Village of Arlington Heights
Plan Commission
Board Room, 3rd Floor
Arlington Heights Village Hall
33 S. Arlington Heights Road
Arlington Heights, IL 60005
January 9, 2019
7:30 PM

REVIEW ROUND 1

Project: European Crystal Hotel LUV Amendment – James Cazares
519 W. Algonquin Road

Case Number: PC 18-021

1 SECOND FLOOR PLAN
1/8" = 1'-0"

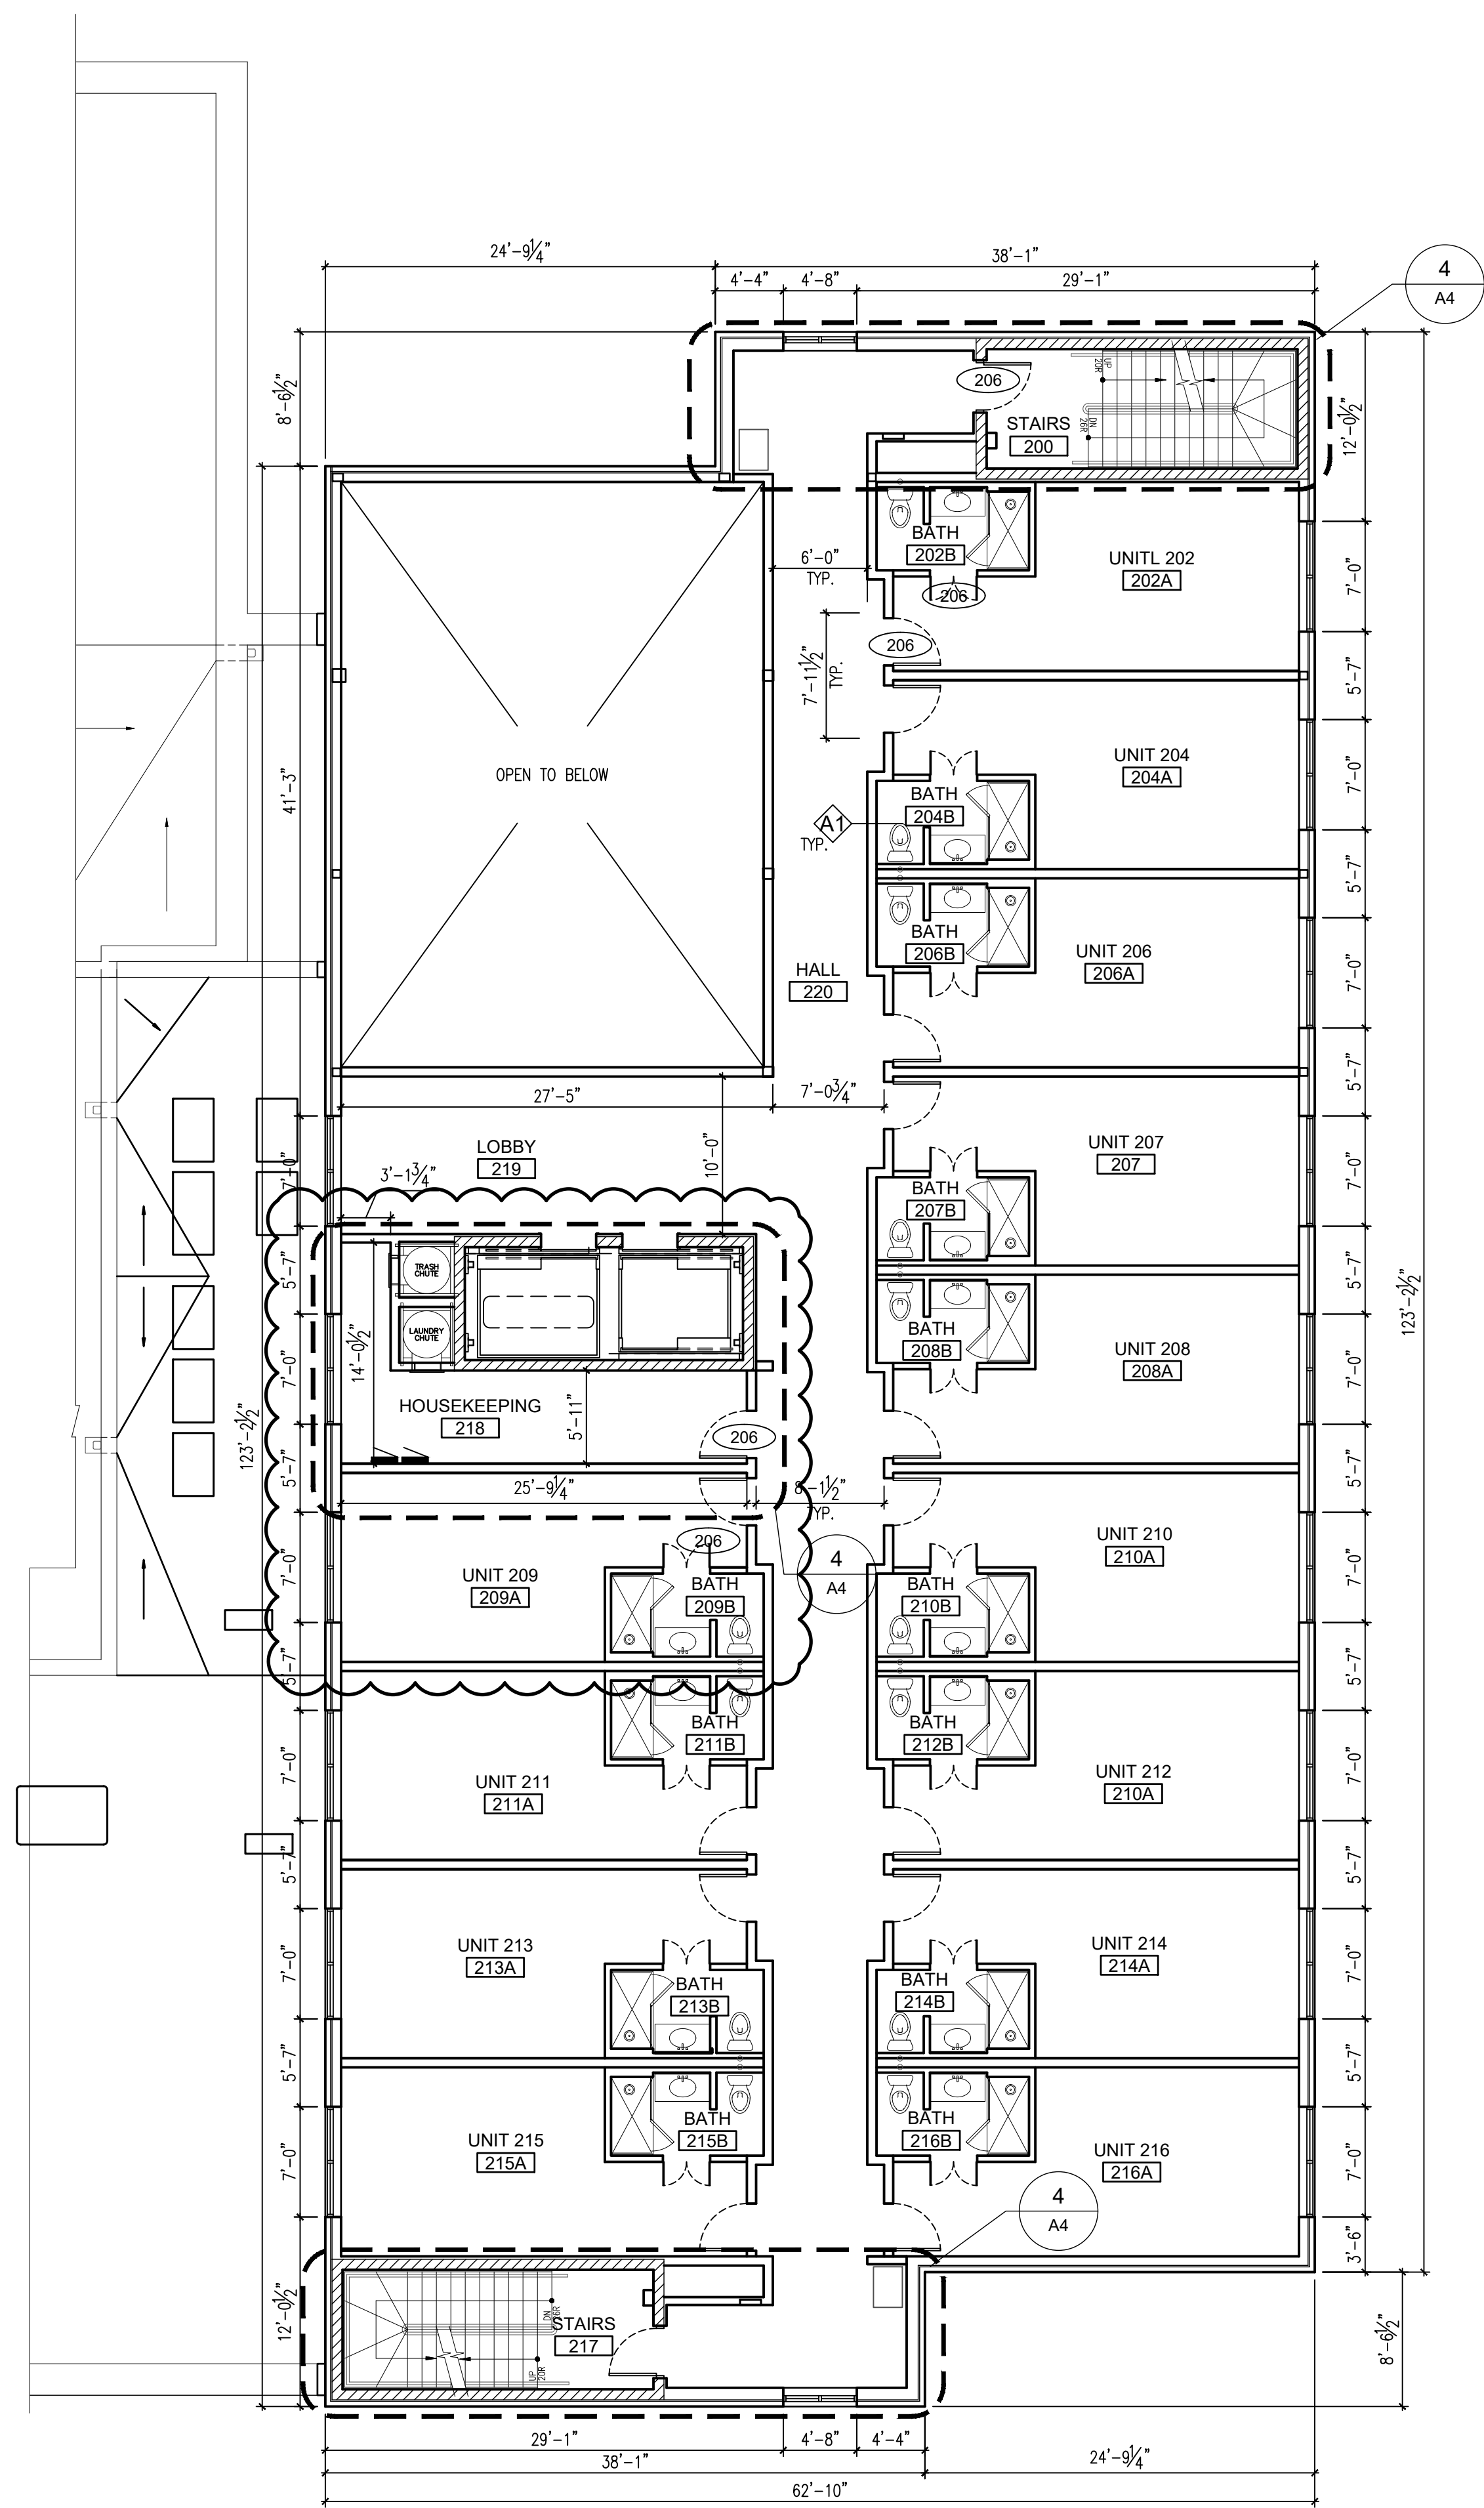
13. Sheet A2 has a label for "Second Floor", which appears to depict the first floor. Please correct.
14. There is an office on the 2nd floor that appears to be a hotel room. Was this office mislabeled, or will this space actually be used as an office?

Figure 4

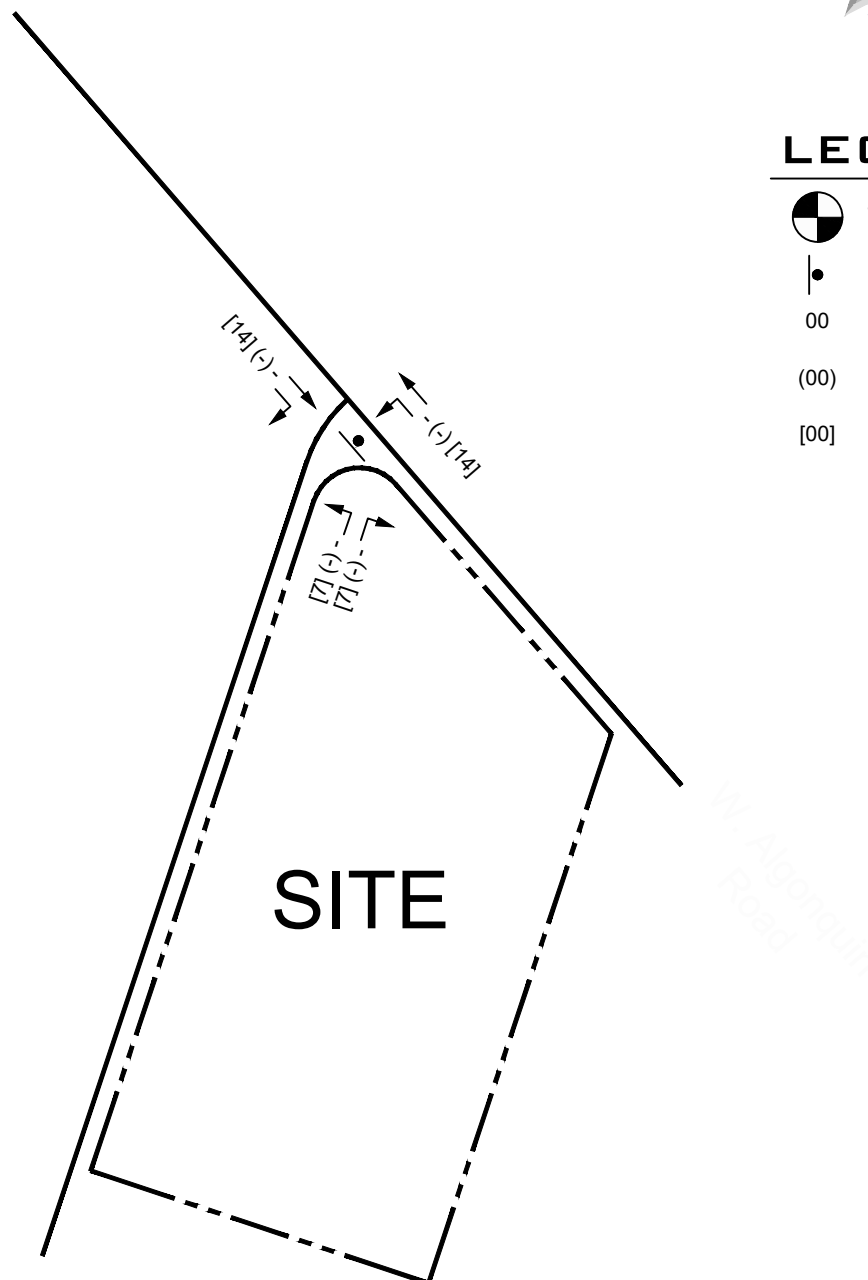
25. The "Existing Volume" in and out data in Table 2 do not match the values from the previous study (Figure 4 from KLOA study). Was a separate survey conducted? Please update the table and associated data accordingly or provide an explanation as to why the data doesn't match.

Response: Separate traffic counts were not completed. The private road that provides access to the banquet hall also serves five other businesses along its length. The traffic volumes on Figure 4 from the KLOA study represents the total traffic movements to and from those six buildings and not just the banquet hall. The table below provides the breakdown of the existing volumes by banquet versus other businesses. The banquet hall is not operating during the morning peak period so all existing traffic was business related. During the evening peak, it was conservatively assumed that all inbound traffic was banquet related and the majority of the exiting traffic was business related. For the Saturday peak, it was assumed that all the vehicles were related to the banquet hall except for a couple of vehicles related to the self-storage facility.
